REMARKS

Serial No.: 10/724,336

Title: SENSING APPARATUS AND METHOD

Amendment to the Drawings

Red-lined Figures are included in attached sheets of Fig(s). 6 and 7. These sheets, which include Figs. 6 and 7, indicate the changes.

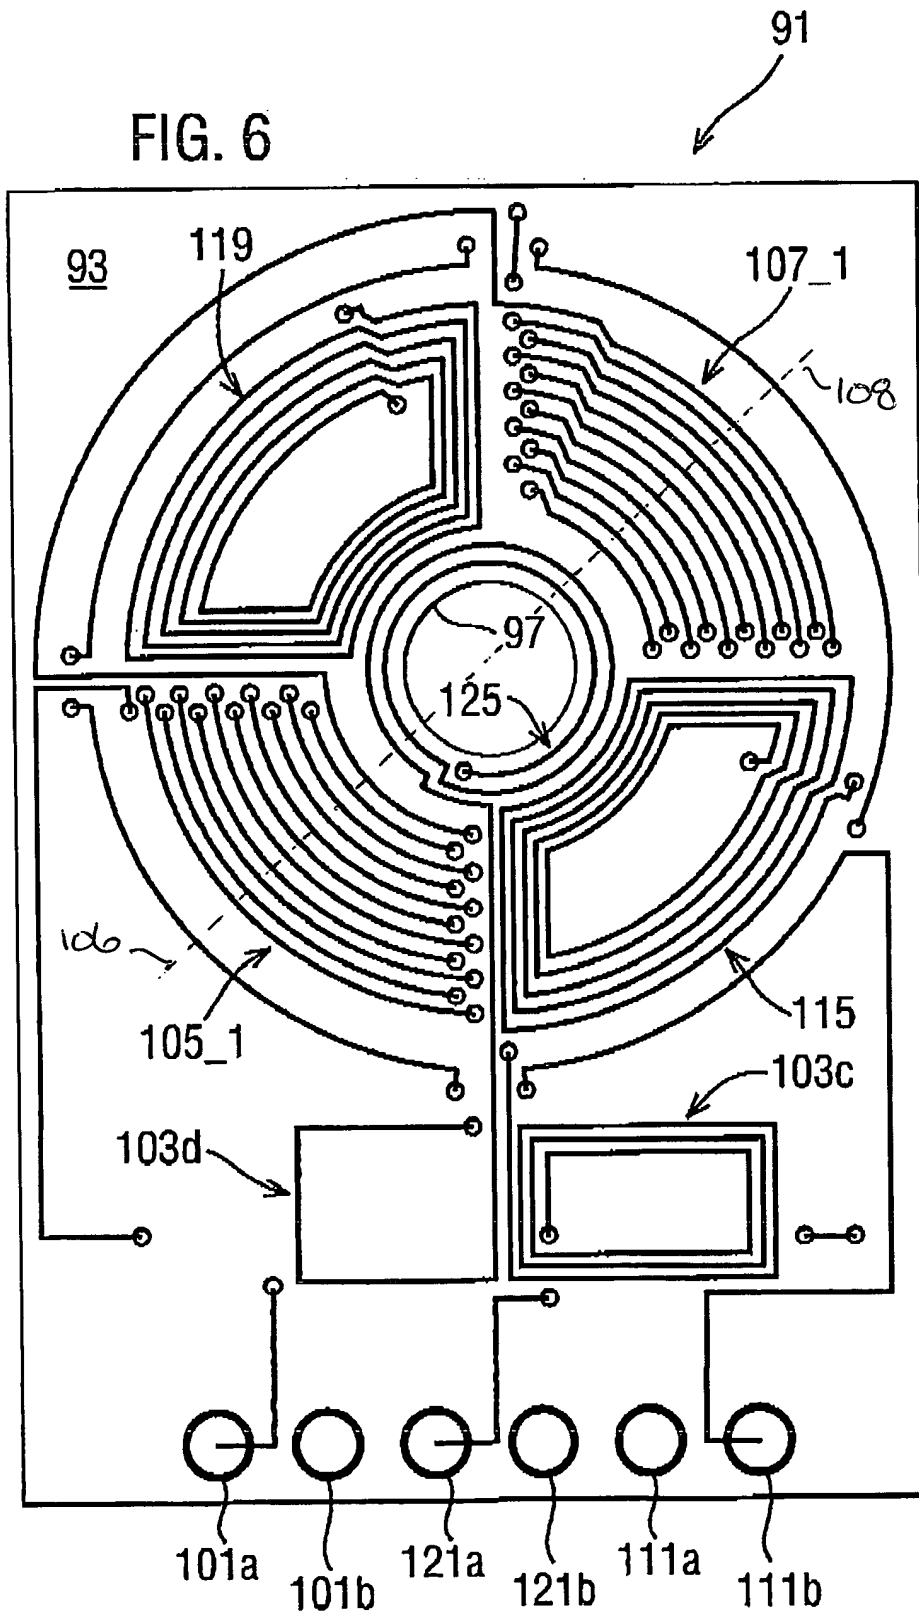
Specifically, in response to the objections set forth in the present Office Action, enclosed are Replacement Sheets 5/14 and 6/14 in which a first radial axis 106 and a second radial axis 108 within the plane of the PCB 91 and a first axial axis 114 and a second axial axis 118 perpendicular to the plane of the PCB 91 have been shown. Furthermore, the specification has been amended to conform with the amended drawings. No new matter has been added.
